Interactive comment on “Assessment of Integrated Watershed Health based on Natural Environment, Hydrology, Water Quality, and Aquatic Ecology” by So Ra Ahn and Seong Joon Kim

MS No.: hess-2017-88 MS Type: Research article Special Issue: Coupled terrestrial-aquatic approaches to watershed-scale water resource sustainability Title: Title: Assessment of Integrated Watershed Health based on Natural Environment, Hydrology, Water Quality, and Aquatic Ecology Journal: Hydrology and Earth System Sciences

Anonymous Referee #1

Figure 1 Comparison of the observed and SWAT-simulated daily dam inflow during the calibration (2005–2009) and validation (2010–2014) periods at (a) HSD, (b) SYD, (c) CJD, (d) KCW, (e) YJW, (f) IPW, and (g) PDD.

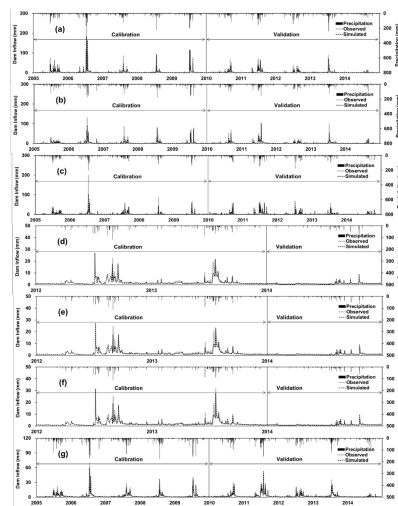
5. Statistical evaluation criteria R2, NSE and PBIAS are all sensitive to high values. Criteria less sensitive to high values, such as Modified NSE and KGE, may could be incorporated.

* Response: (Lines 281-284) We added NSE with inverse discharge (1/Q) in Table 2. We added new sentences: "Additionally, model calibration and validation included the NSE with inverse discharge (1/Q) for low flow. The average NSE with inverse discharge (1/Q) during the calibration (2005–2009) and validation (2010–2014) periods was 0.35 at HSD, 0.53 at SYD, 0.30 at CJD, 0.54 at KCW, 0.47 at YJW, 0.69 at IPW, and 0.58 at PDD."

Figure 2 Comparison of the observed and SWAT-simulated daily sediment during the calibration (2005–2009) and validation (2010–2014) periods at (a) SG, (b) CSG, (c) JW, (d) KCW, (e) YJW, (f) IPW, and (g) PDD.

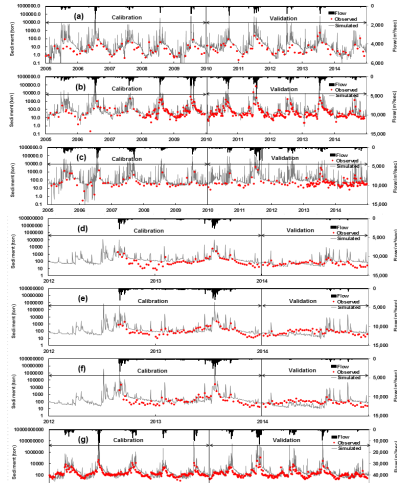
7. Page 9 line 226: "The calibrated parameters and hydrograph of the calibration results in the Han River basin were described by 227 Chung et al (2017)." Parameter definition, physical meaning, range used for calibration and calibrated values are very important information. Please describe this information in supplementary materials to prove that your calibration and validation is reliable.

* Response: (Lines 260-268) We added new sentences about information for parameter definition and physical meaning as follows: "In this study, both calibration and validation were manually performed using a trial-and-error approach within recommended ranges to maximize the expert knowledge of watershed characteristics and modeling experience. The final values were selected based on a statistical evaluation of the performance measures. Twenty of the most influential parameters were selected for calibration. These parameters are related to surface runoff (CN2, CNCOEF, SURLAG, OV_N, and CH_N), evapotranspiration (ESCO), soil water (SOL_AWC and SOL_K), groundwater (GW_DELAY, GWQMN, ALPHA_BF, REVAPMN, and GW_REVAP), and reservoir operation (RES_ESA, RES_EVOL, RES_PSA, RES_PVOL, RES_VOL, RES_K, and EVRSV) processes." As shown below, adjusted parameter values and definitions were included in Table 1 of Chung et al (2017).
